## VAN DYCK PARK MASTER PLAN

## Appendices

### *Appendix A. Public Engagement*

City of Fairfax Parks & Recreation **50 & FORWARD**  
Existing Conditions Assessment - Base Map

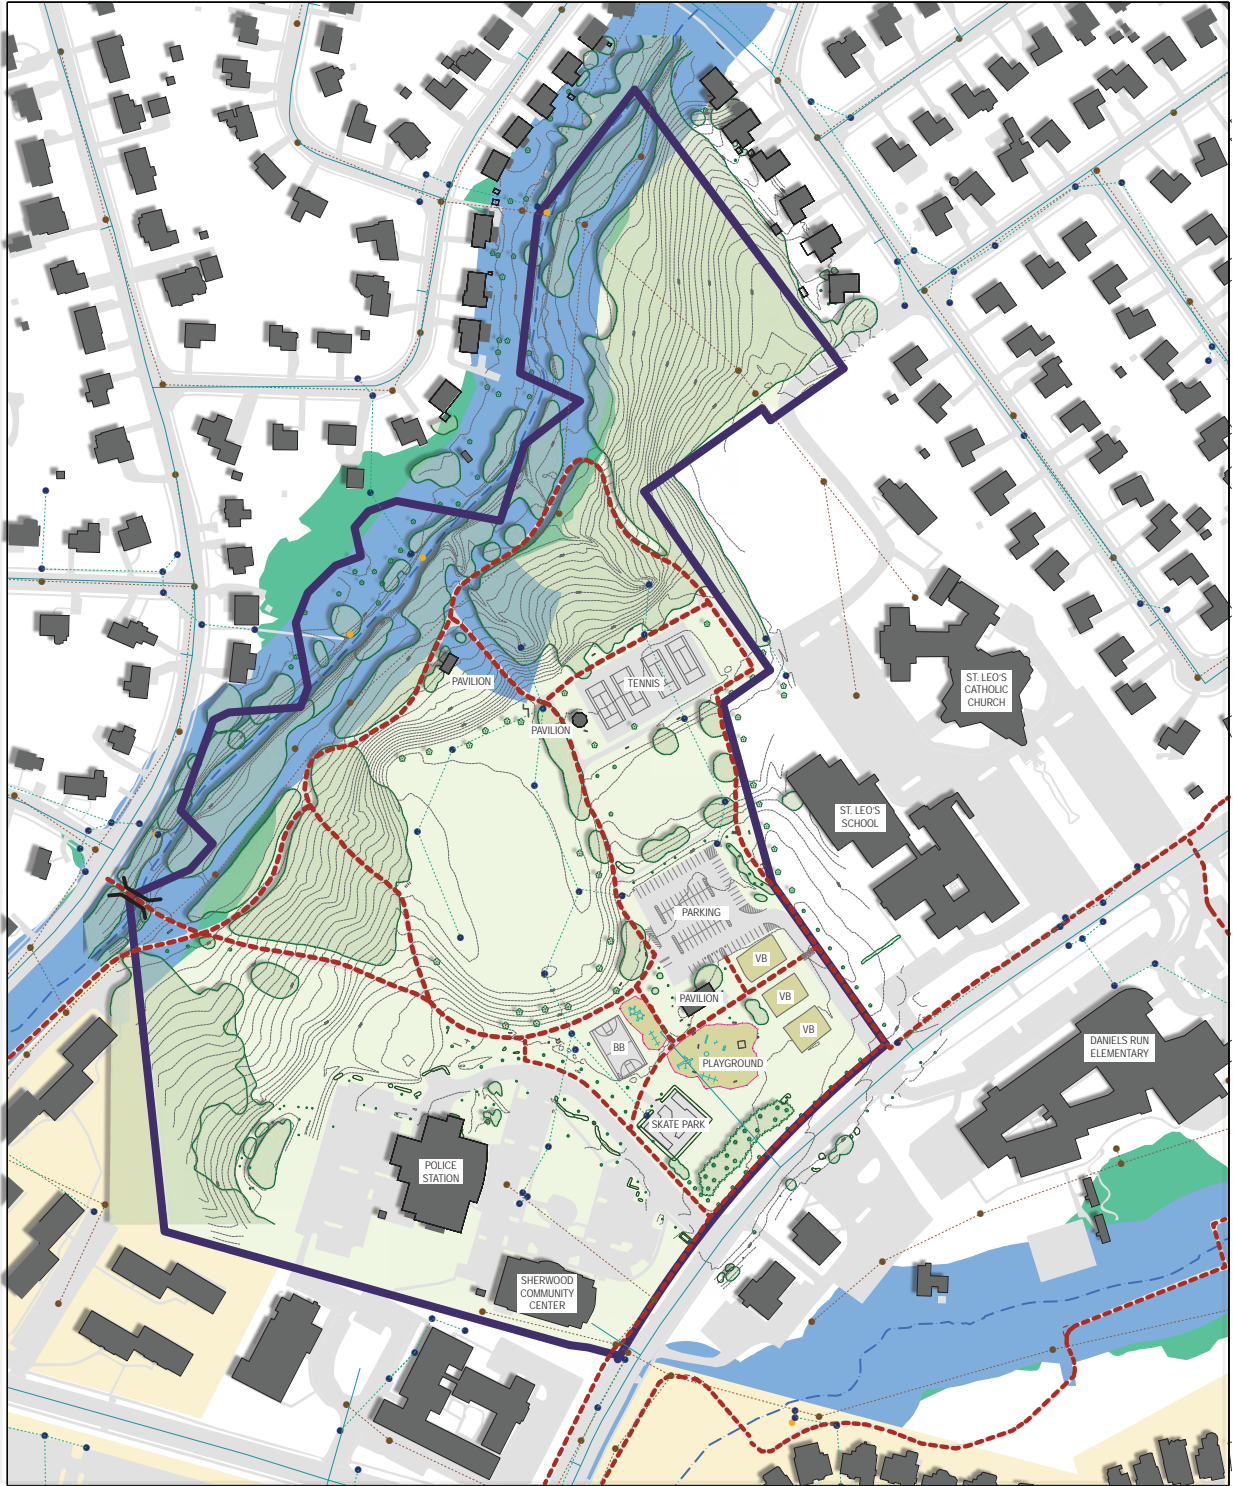
- Send survey and current base map to Cathy.
- Map - put property lines on map; add road names; add date for City floodplain layer
- Cathy to provide stream study information (Accotink)
